**LOT 95**  
SITE/GRADING PLAN  
DIAMONDVIEW PHASE 3

Kollaard File # 230021 – LOT95

**Re: Proposed Single Family Dwelling, Lot # 95 Silver Dart Private, Diamondview Estates, Carp, City of Ottawa, Kollaard Associates File # 230021**

With regard to structural issues only, Kollaard Associates has reviewed the following drawings:

FOUNDATION PLAN (R ELEVATION)

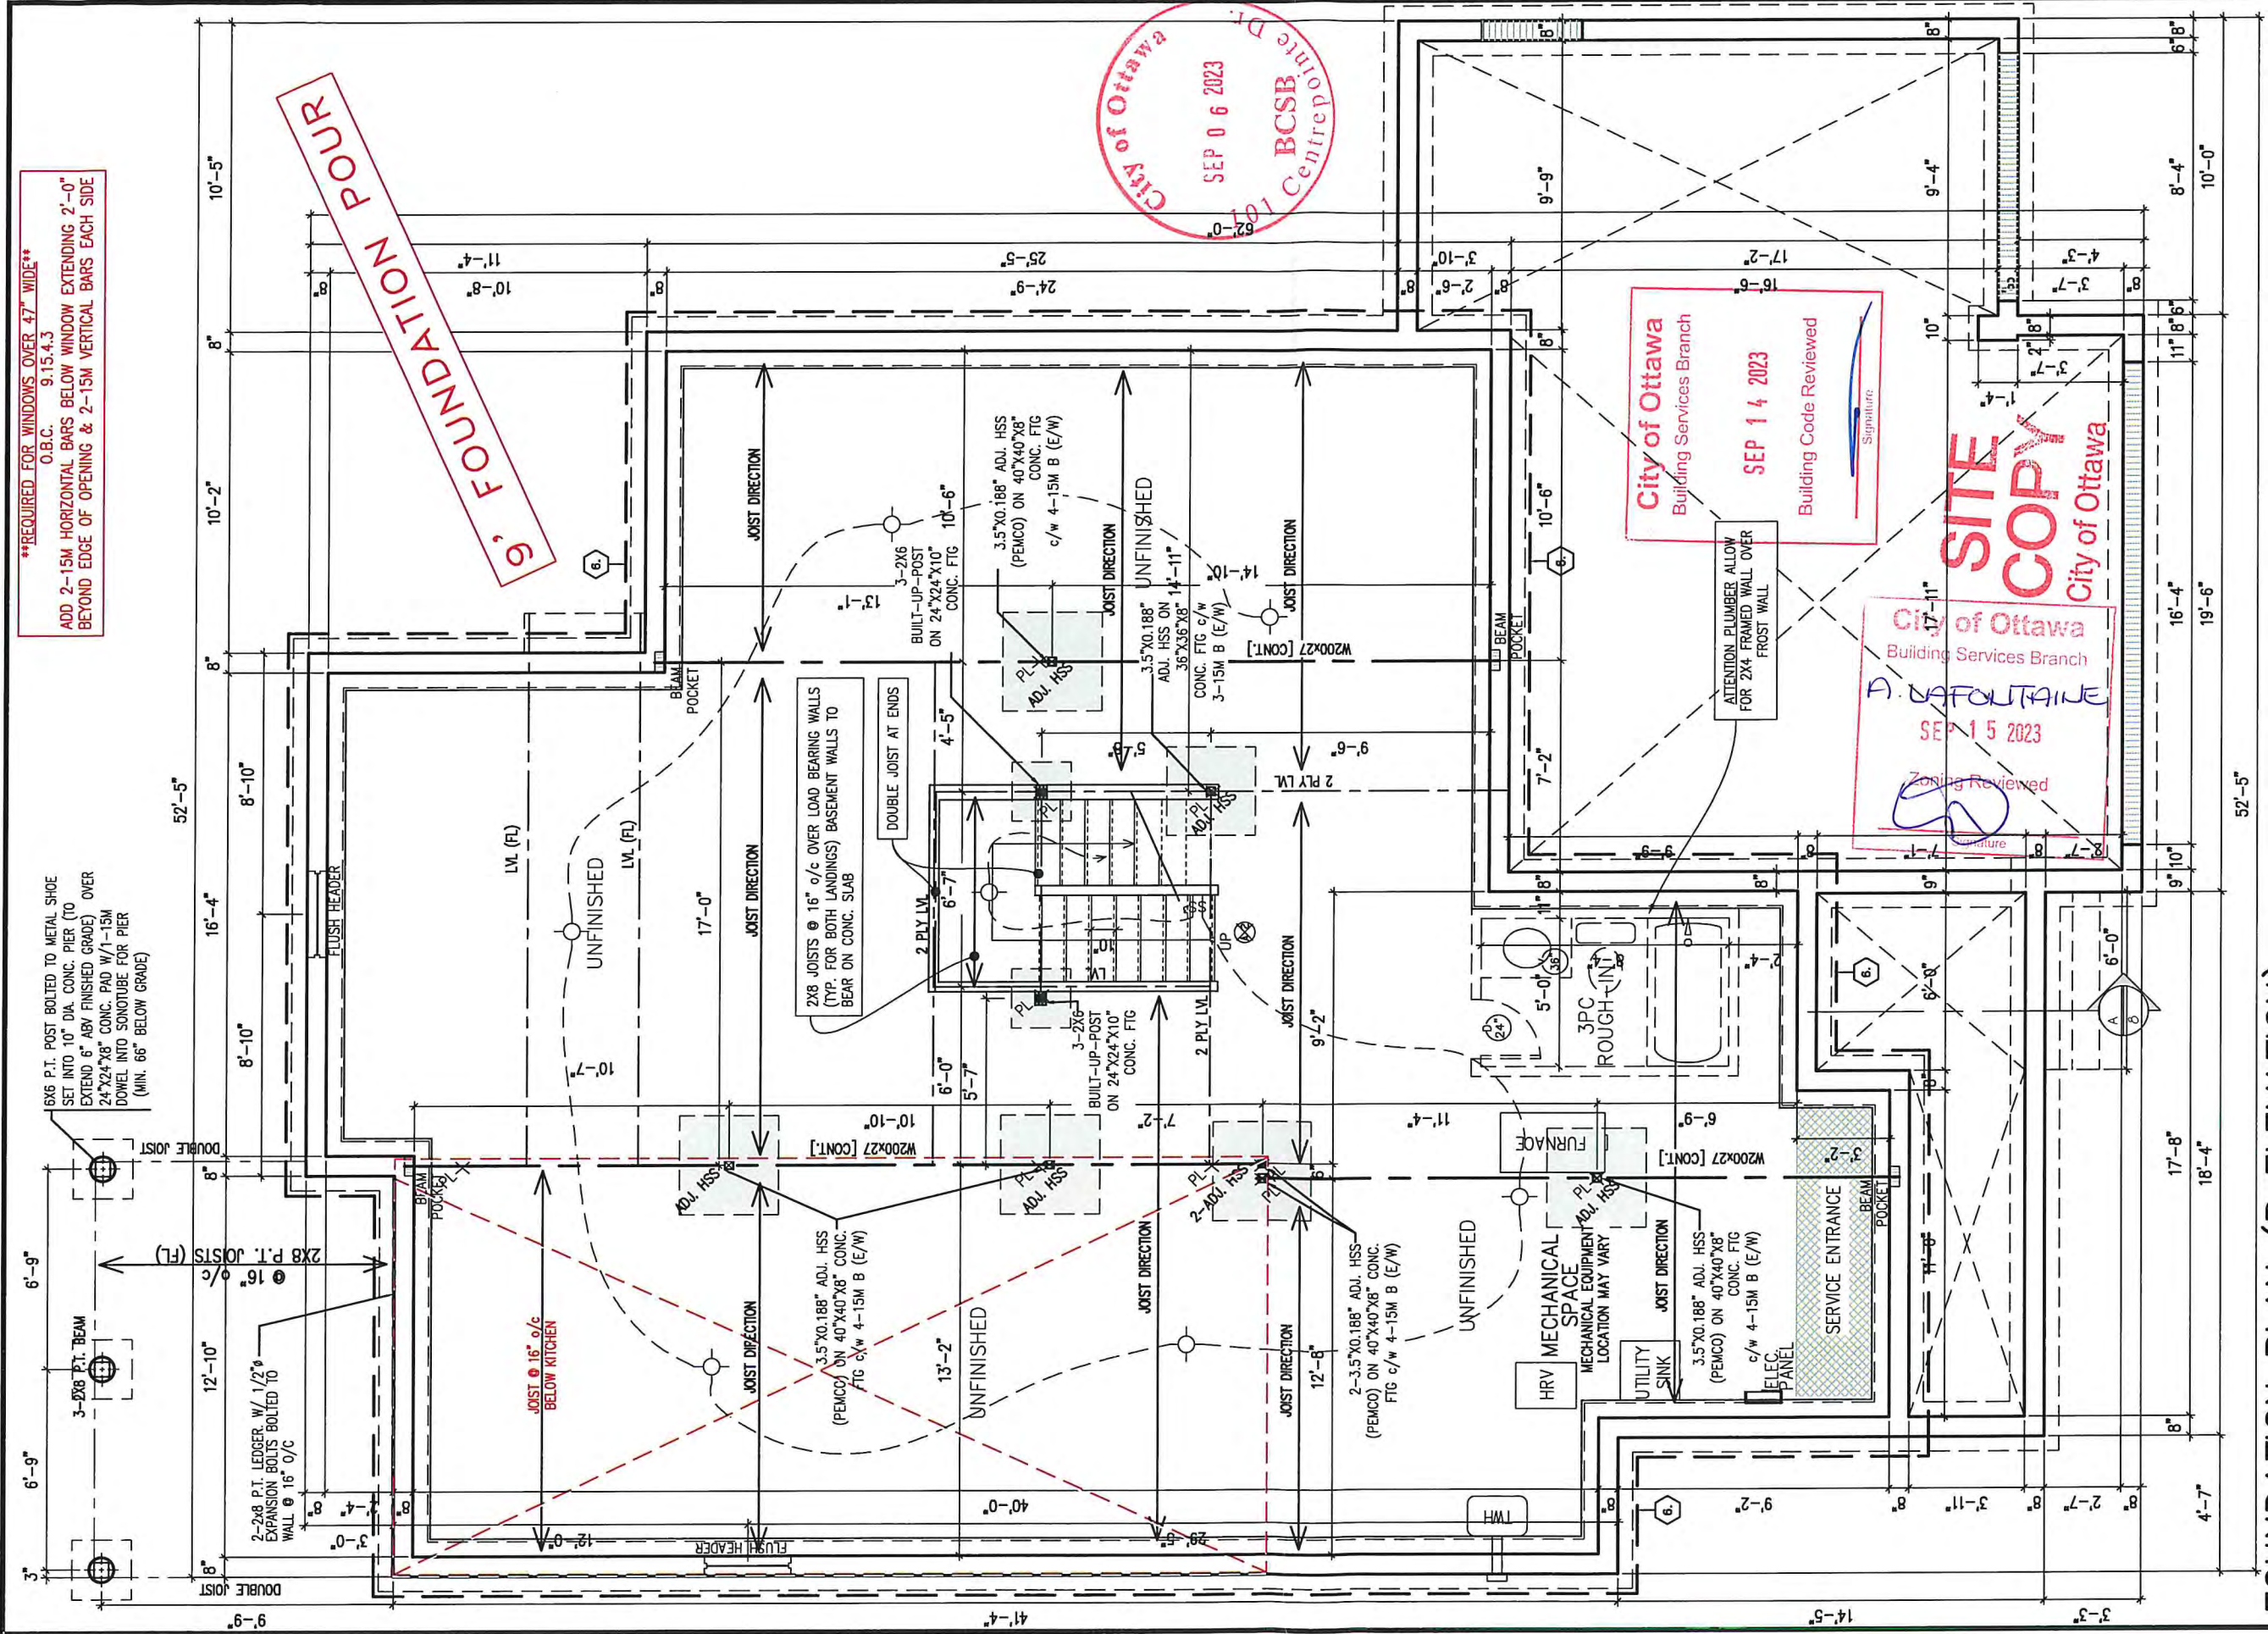
Basement Plan – Pages # 2R:

10. It is the opinion of Kollaard Associates that the proposed steel beams steel posts shown on Phoenix Homes Pages # 2R are adequate.
11. The front porch slab reinforcement described on Phoenix Homes Pages # 1R is adequate.

12. The proposed rear deck beams, posts, joists, ledger connections and sonotubes shown on Phoenix Homes Pages # 2R are adequate.
13. The foundation walls at the bottom of the window openings that exceed 47¼" in width (or the sum of the widths of the window openings exceed 25% of the length of the wall) are considered to be laterally unsupported as per 2012 OBC 9.15.4.3. The proposed reinforcement noted on Phoenix Homes Pages # 2R is adequate to withstand the lateral earth pressures.

14. The remaining proposed foundation walls conform to 2012 OBC Table 9.15.4.2.A. ensuring that the grade difference between the basement slab and the exterior grade (including the garage slab) does not exceed 7'-6½" for the full height 8'-10" foundation walls.

15. The proposed strip footings, interior pad footings and exterior pad footings shown on Phoenix Homes Page # 2R and noted on Phoenix Homes Page # 1R are adequate.

16. Floor joist design, flush LVL beams within the floor structure and LVL lintels are by the manufacturer. The posts supporting the flush LVL lintels shown on Phoenix Homes Pages # 2R are adequate.

# GROUND FLOOR PLAN (ELEVATION R) 1782 SQ. FT.

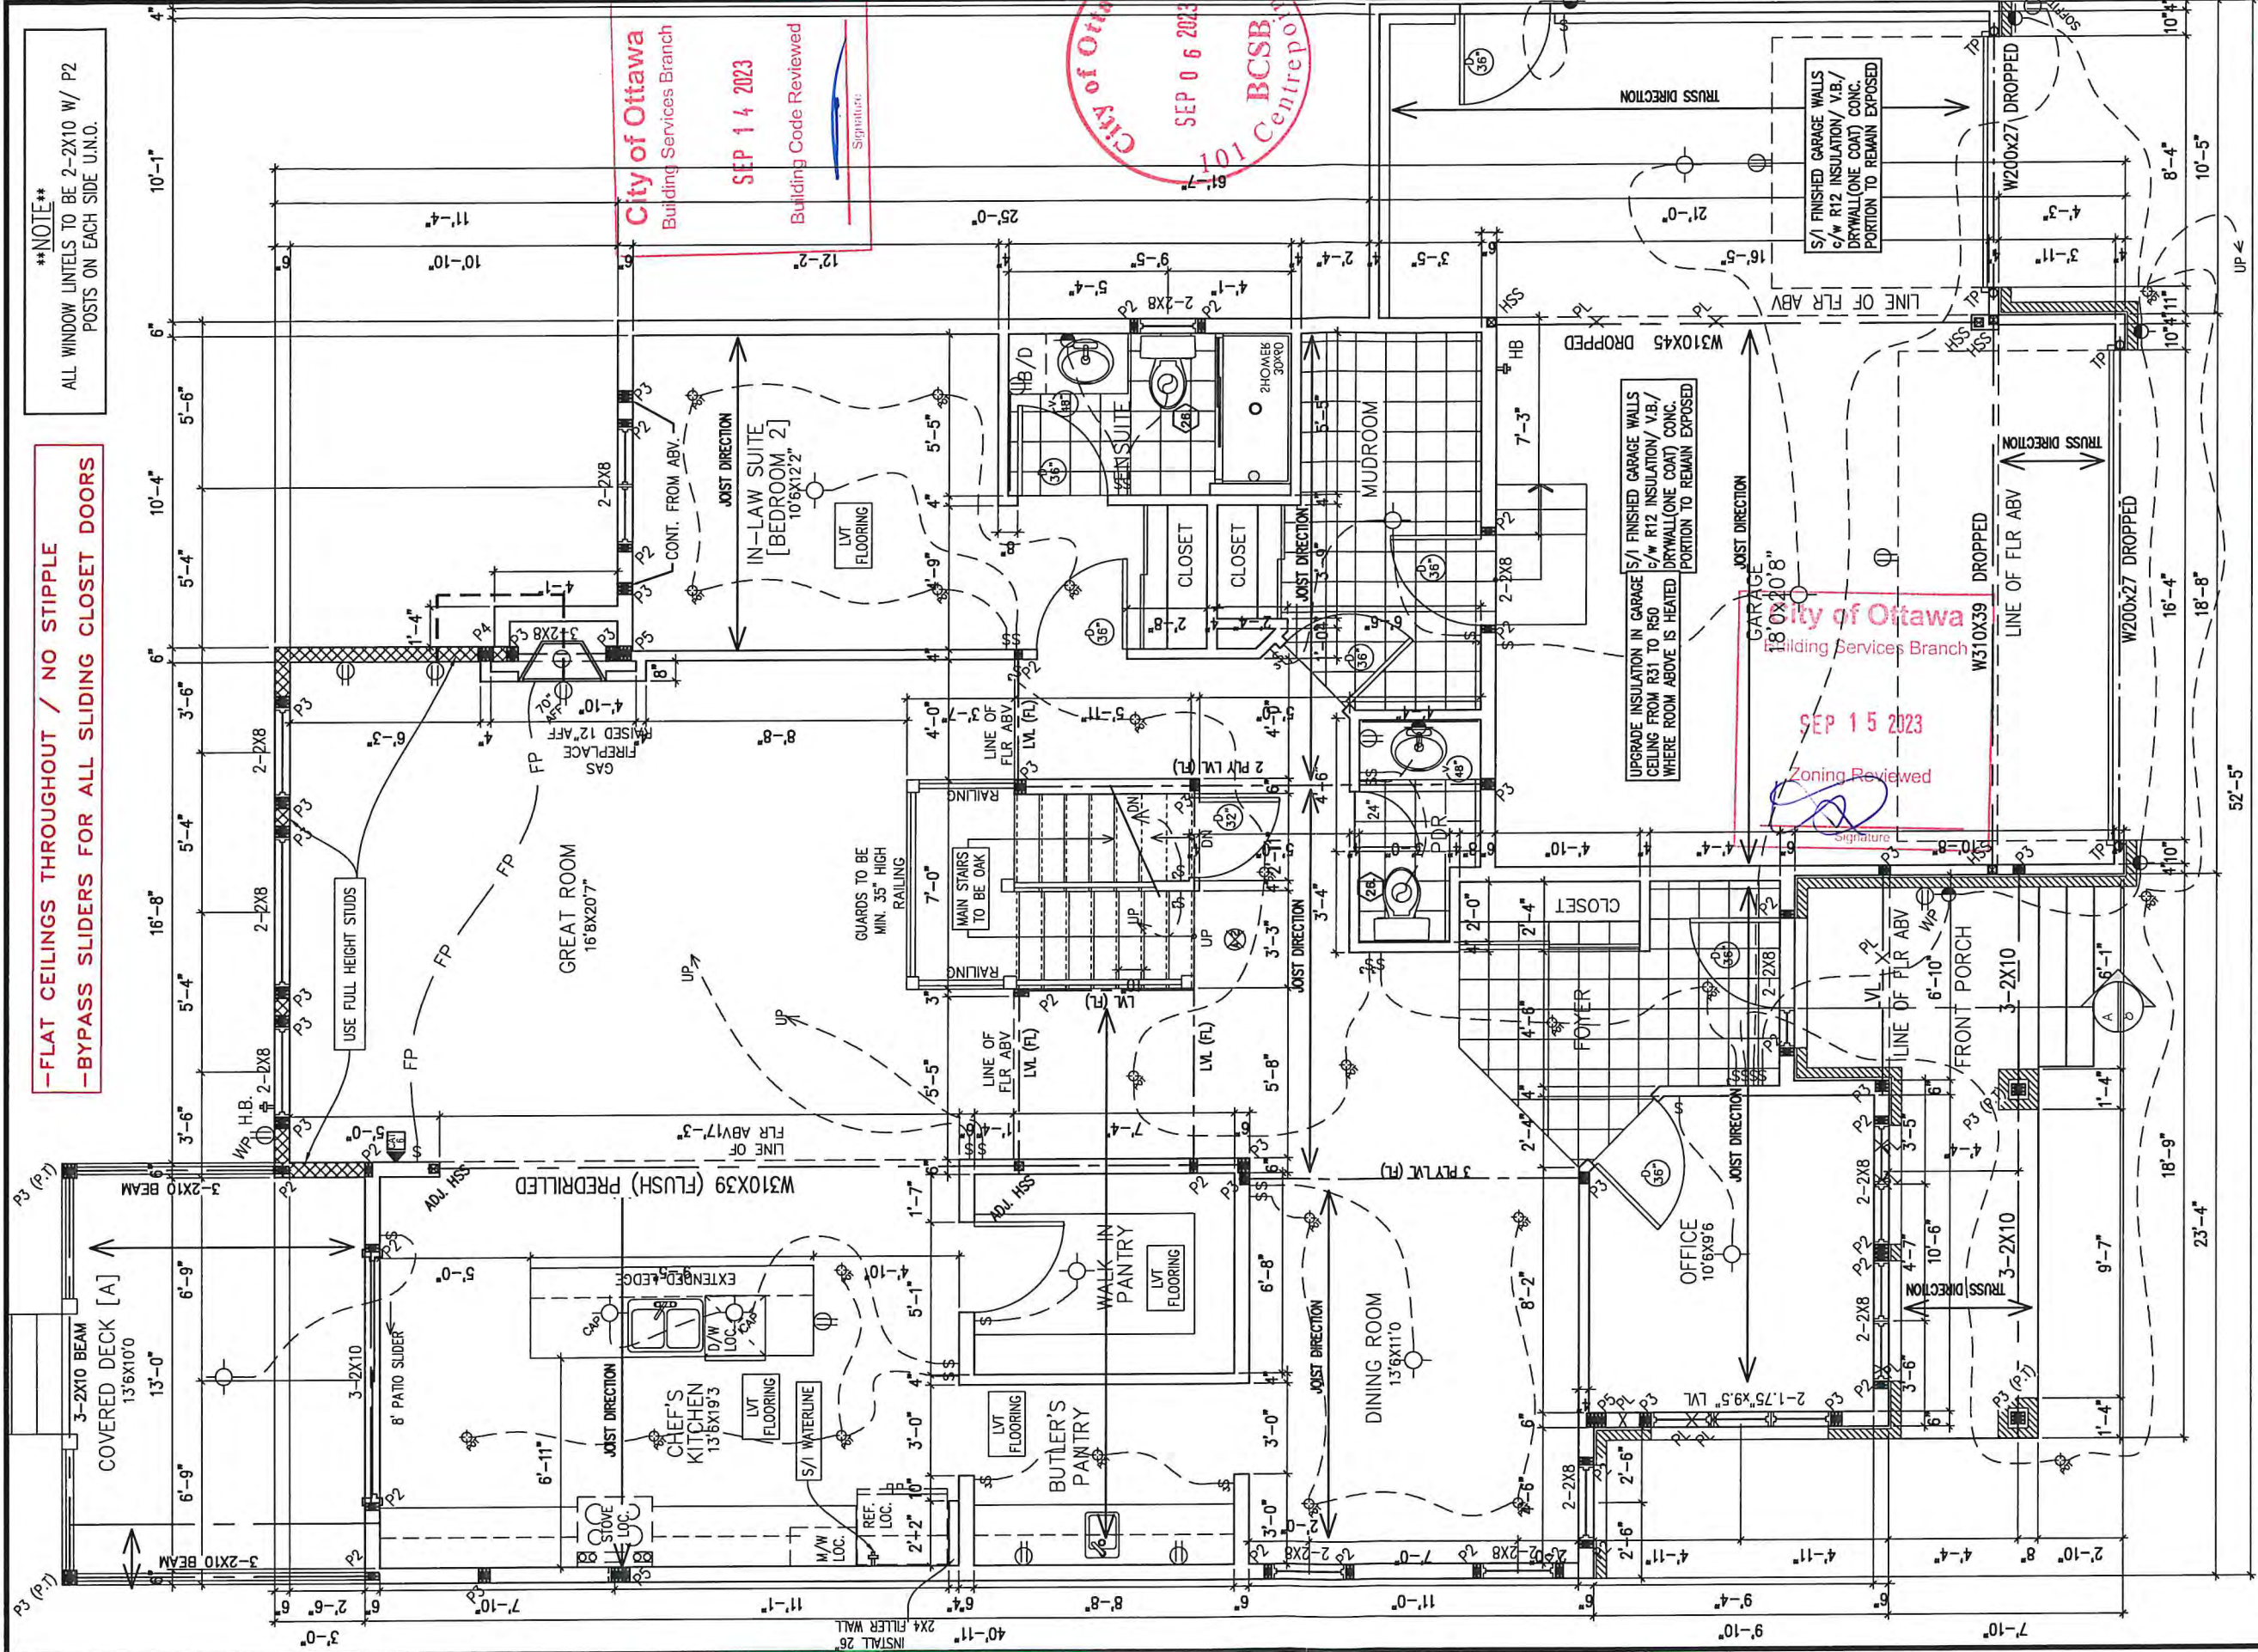
Ground Floor Plan – Pages # 3R:

5. It is the opinion of Kollaard Associates that the proposed lintels, beams and supporting posts shown on Phoenix Homes Pages # 3R are adequate.

6. Ramset a 2x6 to the top flange of all steel beams to attach the above framing, floor joists and flush LVL beams.
7. The proposed web packing of the web of the steel beam to fasten the face mounted hangers shown on Phoenix Homes Pages # 9R is adequate.
8. Truss design is by others.
9. Floor joist design and flush LVL beams within the floor structure are by the manufacturer.
